EAST TOWN CROSSING - LOT 1
RETAINING WALL

EAST TOWN CROSSING
RETAINING WALL AT COMMERCIAL LOT 1
727 SHAW ROAD PUYALLUP WA

REVISIONS
DRAWN BY: BL / CM
CHECKED BY: BL
DATE: 25.11.18
TITLE: RAMP PLAN
PROJECT #: 2016
SHEET:

AGENCY SUBMITTAL - REVISION No.1 | 25.11.18

1 OVERALL SITE PLAN
SCALE: 1" = 50'

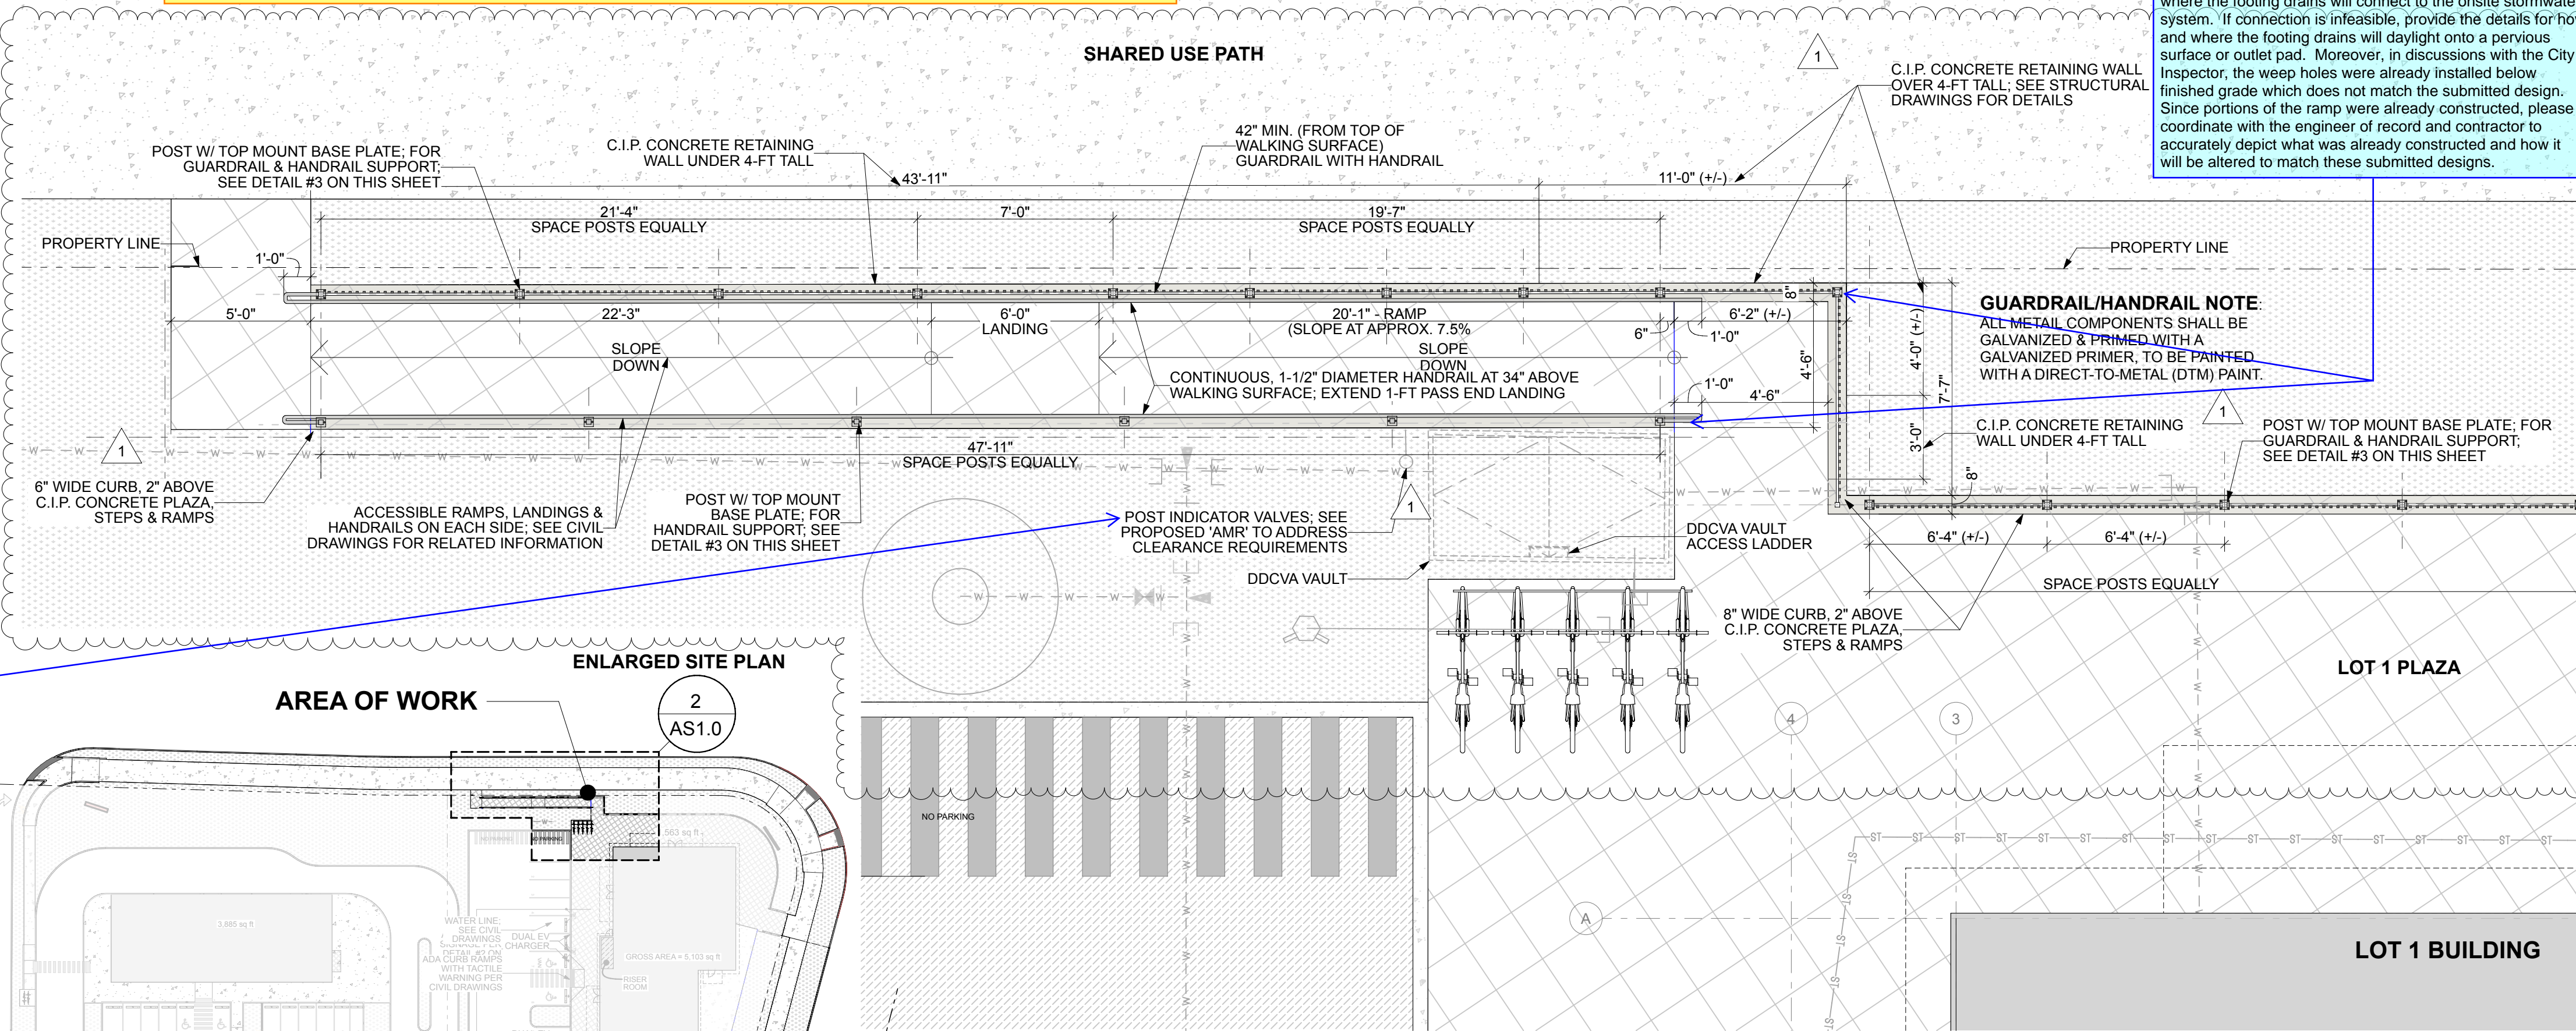
FIRST REVIEW CORRECTION: Depict and label how and where the retaining wall foundation drains will connect to the onsite stormwater system.

SECOND REVIEW CORRECTION: The discussion between the engineer of record and City Review Engineer, Mark Higginson, was only to allow the weep holes which daylight onto pervious surfaces. The City Review Engineer did not waive the footing drain requirement which is still depicted on the structural drawing details. Depict and label how and where the footing drains will connect to the onsite stormwater system. If connection is infeasible, provide the details for how and where the footing drains will daylight onto a pervious surface or outlet pad. Moreover, in discussions with the City Inspector, the weep holes were already installed below finished grade which does not match the submitted design. Since portions of the ramp were already constructed, please coordinate with the engineer of record and contractor to accurately depict what was already constructed and how it will be altered to match these submitted designs.
